### Proposed Revisions to a Standard Plans Index

Index Number: 700-030

Index Title: WIND AND HANGER BEAMS FOR OVERHEAD  
SIGNS

FRONT ELEVATION

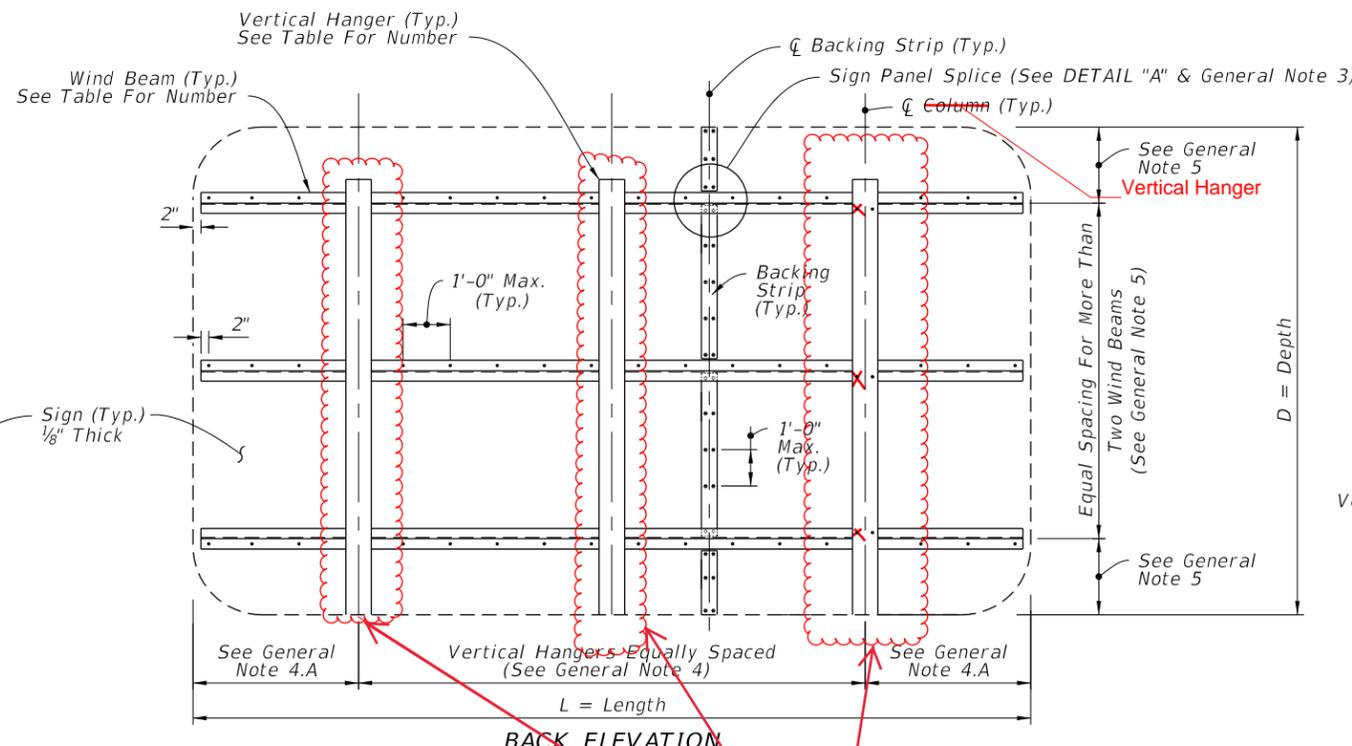
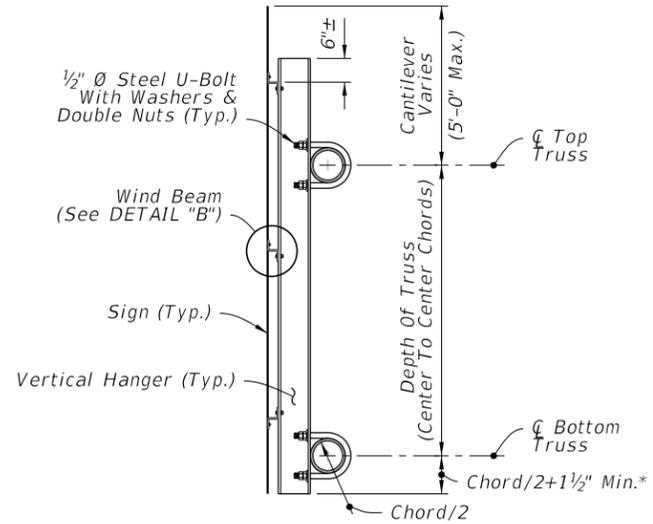
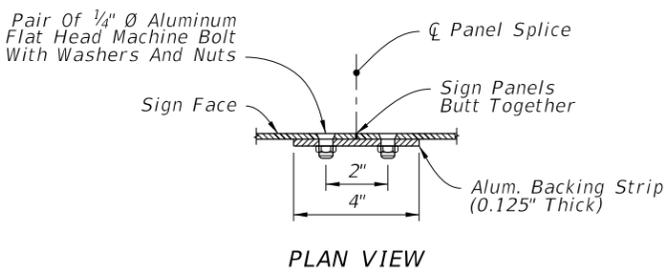
Sheet 1: Revise the bolts in the Hanger Beams to show correctly. Added language to Detail B bolt call out to clarify number of bolts required.

We received a query about the required number of bolts per intersection of the hanger beam and the wind beams. The bolts were not showing correctly in the elevation details so we corrected it.

Only show one bolt per intersection and show the bolts on the other beams as well.
